DETAILED ACTION

Response to Amendment

This office action is responsive to the amendment filed on 03/21/2011. As directed by the amendment: claims 1, 3, 7 and 9, have been amended, claims 2 and 4 have been cancelled, and new claims 10-12 have been added. Thus, claims 1, 3, 7 and 9-12 are presently pending in this application.

Marked-up portion of Fig. 3

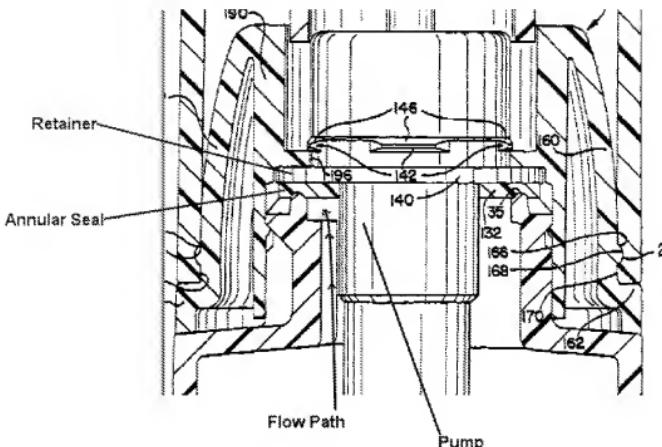
Regarding claims 1, 3, 9 and 10, as best understood Garcia discloses a dispenser pack including a "standard metering pump," a container 24 having a neck 32, a closing cap 130, a cylindrical wall 190 that encloses an axial aperture 192 that is arranged above an internal flange 196 (see marked-up portion of fig. 3); a retainer 140

for attaching the pump within the aperture 192 of the closing cap 130, wherein an exterior flange of the retainer 140 can be pressed against an annular seal 132 on an outer face of the container neck 32 so as to be sealed by the closing cap 130; a pump housing including a pump cylinder 141 that surrounds a pump chamber whose upper end includes an aperture and whose lower end includes a suction pipe nipple freely exposed (see figures 2 and 3); and a piston shaft 148 which protrudes outward from the pump chamber and at its outer end includes an activation head 16 (see figure 2). Garcia further discloses that the volume of the container 24 that contains the free-flowing medium can be adjusted to the decrease of the volume of the free-flowing medium to be dispensed from the container 24; and a inner hole rim of the seal 132 forms an annular lip resting against the outside of the pump housing 141 so as to close a flow path formed between the retainer 140 and pump (see marked-up portion of fig. 3).

With further respect to claims 1, 3, 9 and 10, Garcia discloses all the elements of the claimed invention except the seal being pressed radially inward in the form of a truncated cone across an annular space in the flow path against the cylindrical outside of the pump housing so as to seal the flow path, wherein the thickness is reduced towards the outer end of the annular lip; and the flow path providing at least temporary ventilation of the container.
